719 Jenifer St
Certificate of Appropriateness
June 5, 2023

Proposed Work

1 EXISTING NORTH ELEVATION

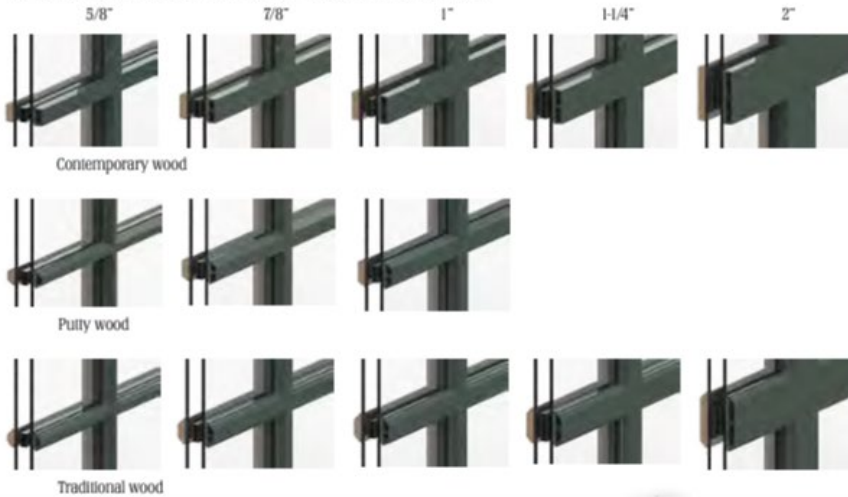
4. The original wood windows on the front of the house and the original front entry door will be repaired, not replaced, with this noted on the updated plans.

3 EXISTING EAST ELEVATION

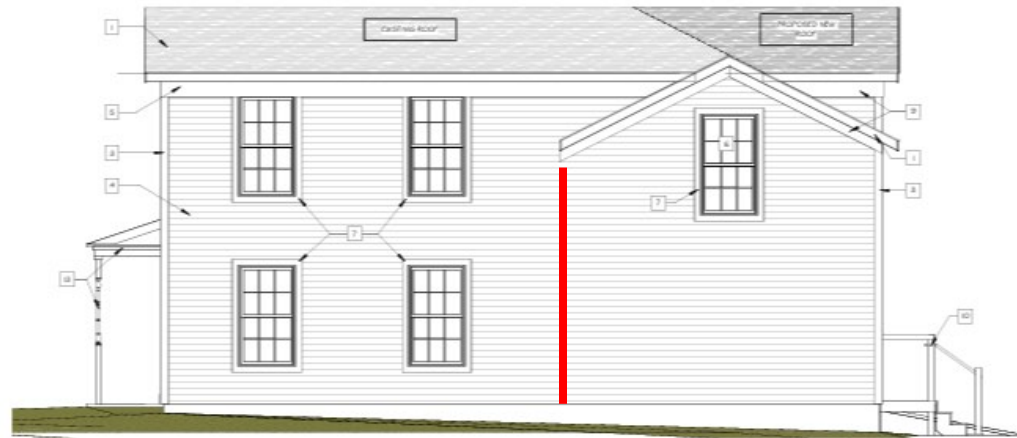
1. Submit updated plans that detail which project items are to be completed for this scope of work and not work that has already been completed. **To include vertical trim beneath side gable.**
